A RESOLUTION REVERSING THE PLANNING COMMISSION'S DENIAL OF A REPLAT AND SITE PLAN FOR PROPERTY LOCATED AT 412 PARKER STREET IN THE CITY OF NORTH LITTLE ROCK, ARKANSAS; AND FOR OTHER PURPOSES.

Item # 17
SD2023-24 Giles Add, Lot A, Blk 9 (Replat & SPR for 28 townhomes @ 412 Parker St)

Preliminary Plat

Site Plan Review

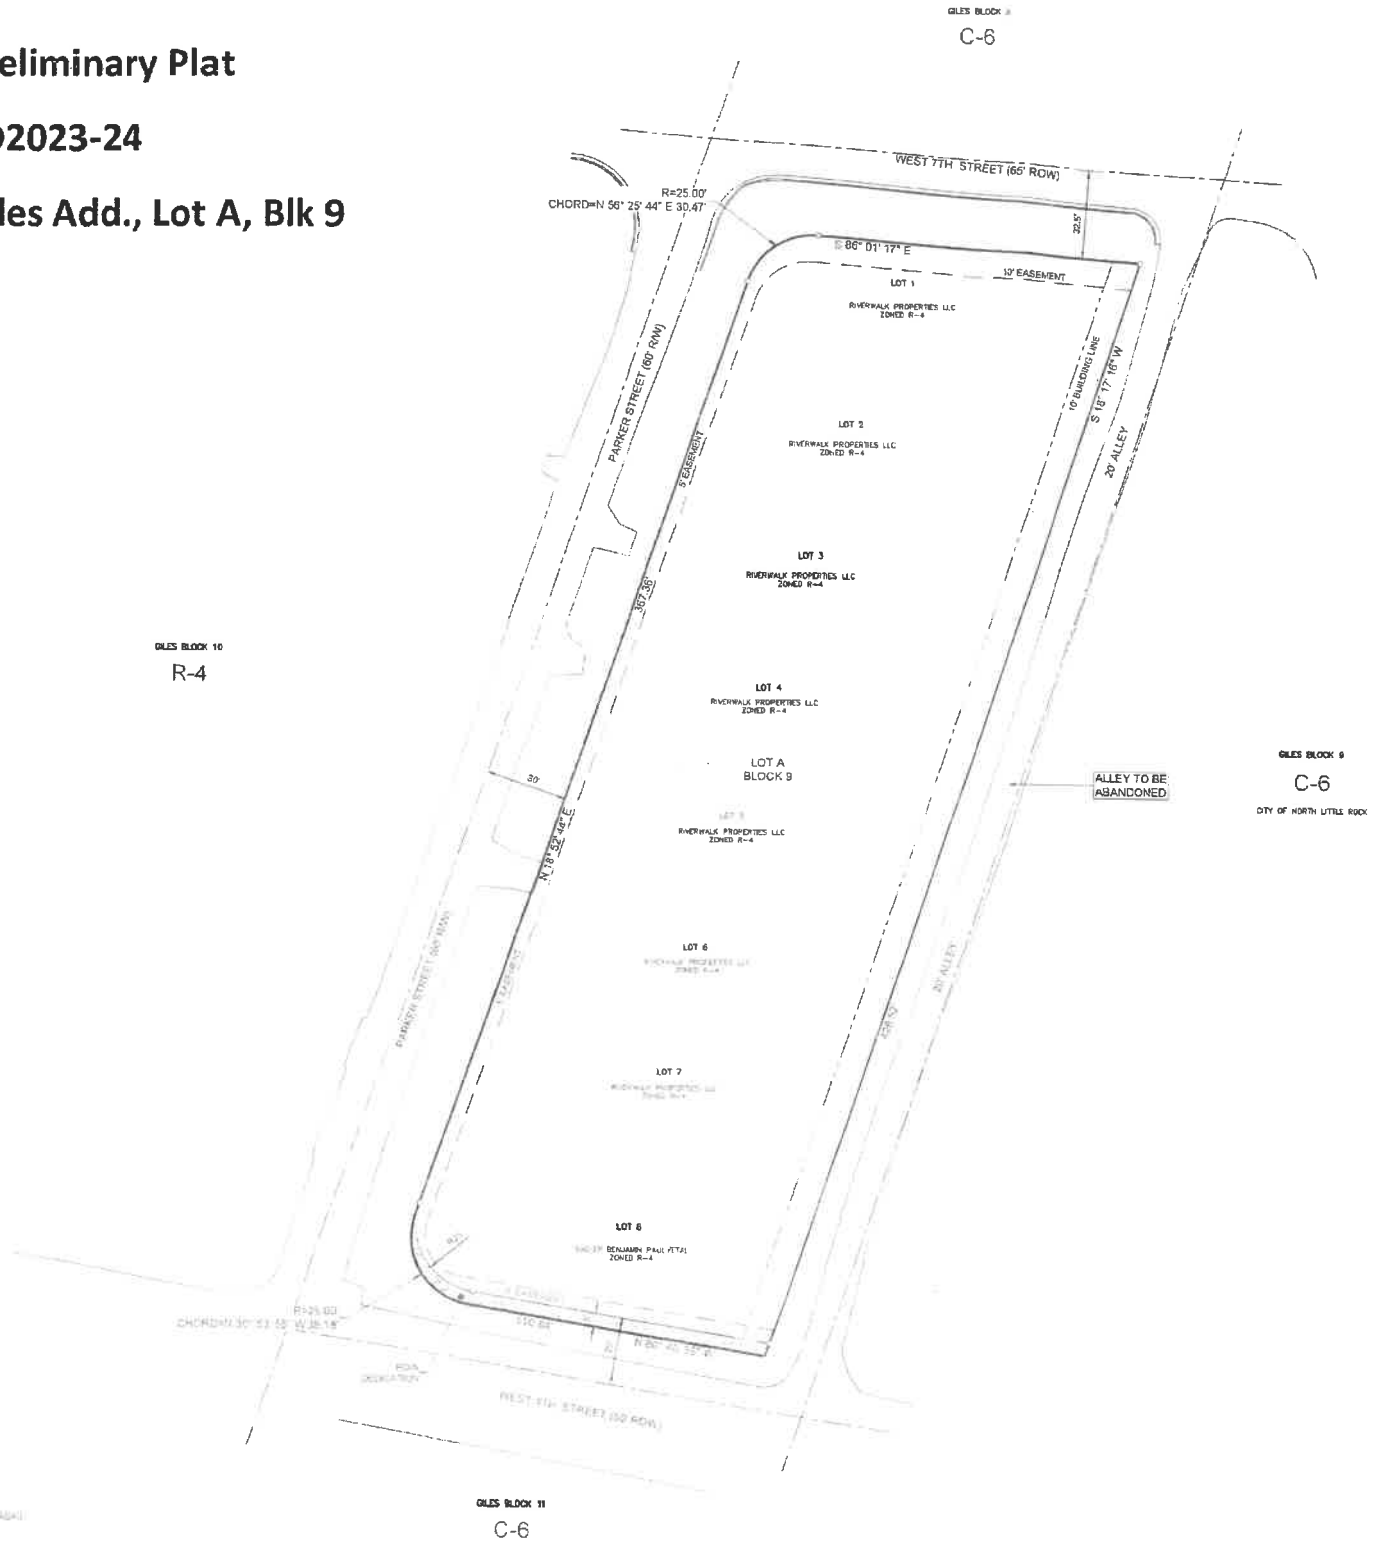
4. **Engineering requirements before the plat will be signed:**
   a. Provide ½ street improvements (street, drainage, curb and gutter, sidewalk, streetlights) or a performance bond.
   b. Provide ROW dedication on W 4th St of 5' as shown on the plat.
   c. Street improvements must be approved by City Engineer and accepted by City Council.
   d. Provide 20' property line corner radius.
   e. Show and label boundary of detention area as a drainage easement, if applicable.

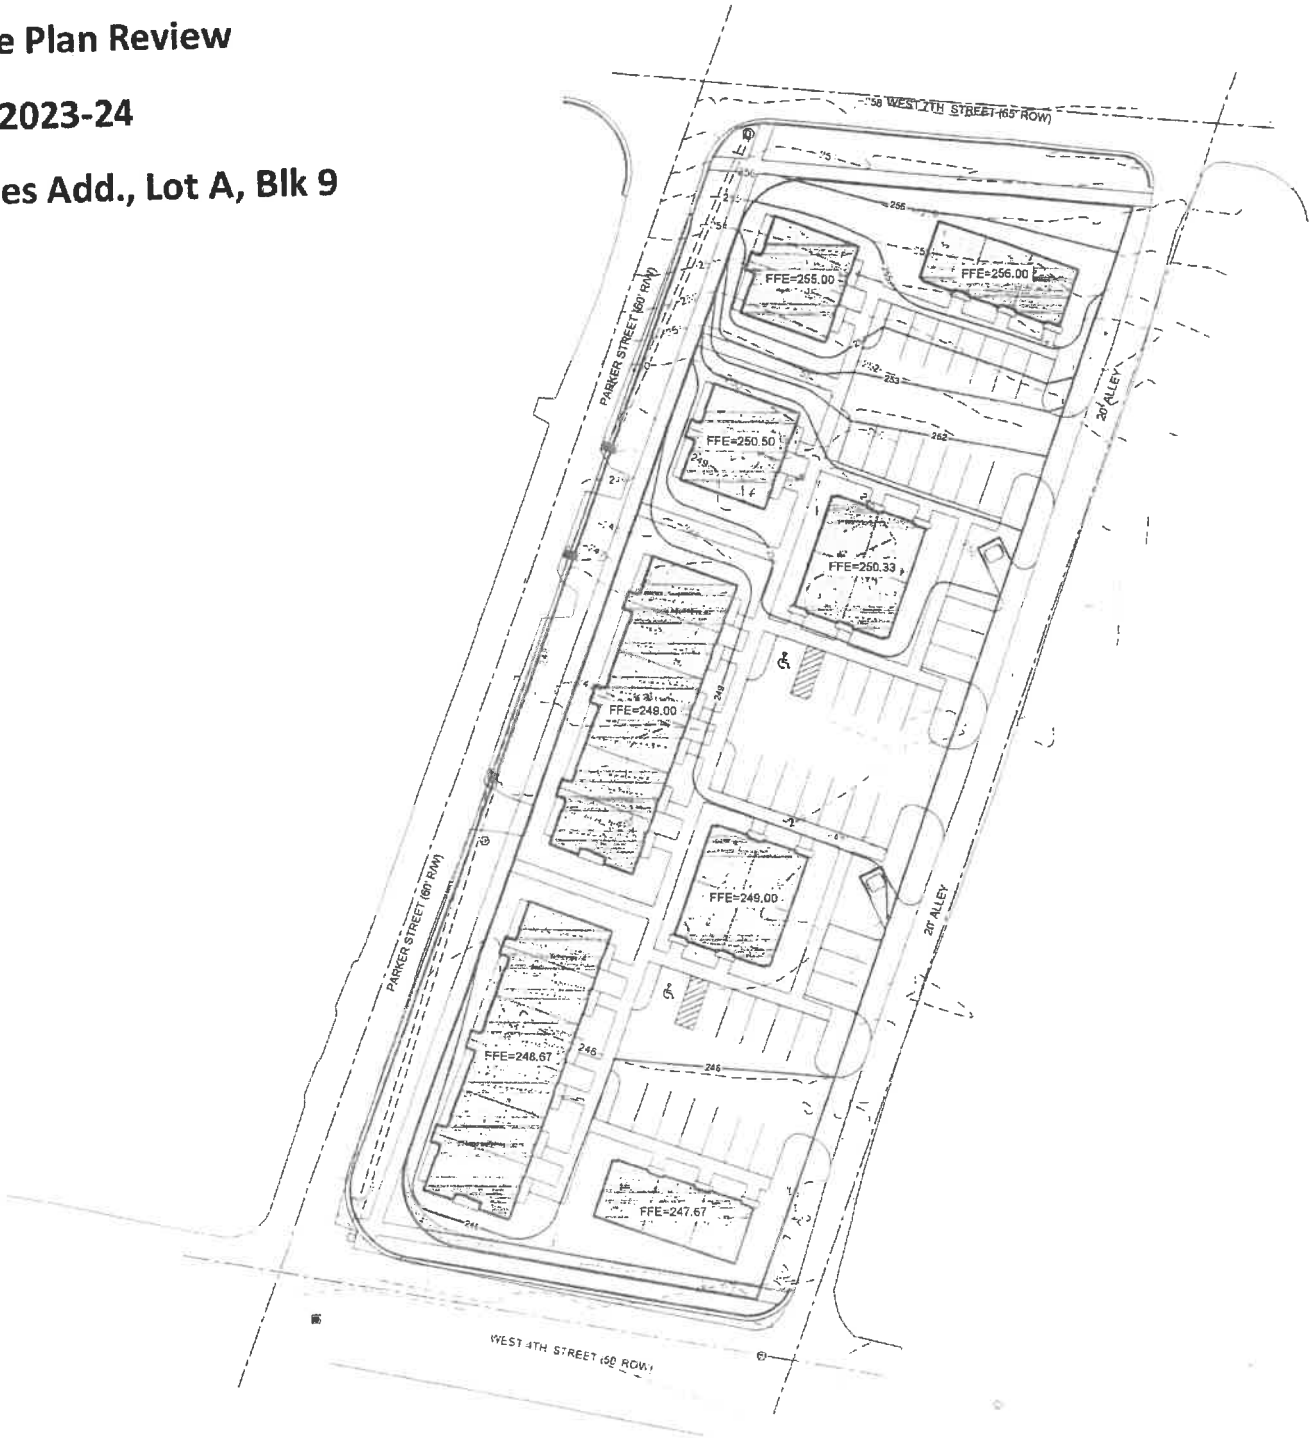
1. **The property is zoned C6 which requires a front setback of zero. Revise the plan to "pull the buildings up to the ROW" on W 4th, W 7th and Parker Streets.**

2. **Driveway radii shall be labeled and shall have 20' minimum radii and be built according to CNLR standard details (available at NLR Engineering Department). The current design shows driveway radii of less than 20'.**

d. Driveways shall not be closer than 40' to adjoining streets or 10' from adjoining property lines.
   e. Spacing between proposed commercial/industrial driveways shall not be closer than 40'.

f. Driveway widths shall be labeled and shall be 10' minimum to 40' maximum.
   g. All driveways are to be concrete within the ROW.

7. **Meet the requirements of the Master Street Plan, including:**
   a. Provide 5' sidewalks and ramps with a minimum of 5' green space between sidewalk and curb to ADA standards and City standards.
   b. Repair or replace any curb and gutter or sidewalk damaged in the public right-of-way with the issuance of a building permit.
   c. Provide ½ street improvements to all abutting streets as required by the City Engineer.
   d. Provide ROW dedication on W 4th St of 5' as shown on the plat.
   e. A 20' radial dedication of ROW is required at the intersection of W 4th & Parker Streets & W 7th & Parker Streets.

9. **Meet the requirements of Community Planning, including:**
   a. Provide the standard requirements of Zoning and Development Regulations.
   b. Dumpster(s) to have masonry screening on three sides and an opaque gate.
   c. No fence is to be located in front of the buildings.
   d. Curb and gutter required on all parking lots. Show or label on drawing.
   e. Wheel stops shall be required when parking areas abut sidewalks, landscaped areas or pedestrian areas. Show or label on drawing.
   f. All exterior lighting shall be shielded and not encroach onto neighboring properties.

10. **Meet the requirements of the Screening and Landscaping ordinance, including:**
   a. All disturbed areas are to be sodded, fertilized, watered and mulched.
   b. Any new site development must comply with the City's minimal landscape and buffer ordinance requirements.
   c. Provide (23) street trees as shown.
   d. Provide (8) parking lot shade trees. Trees 10' feet from the edge of parking area may serve for the parking lot shading requirements.
   e. Provide a continuous row of shrubs around parking areas.
   f. Note turf, groundcover, or mulch (species or type) on the development plan.
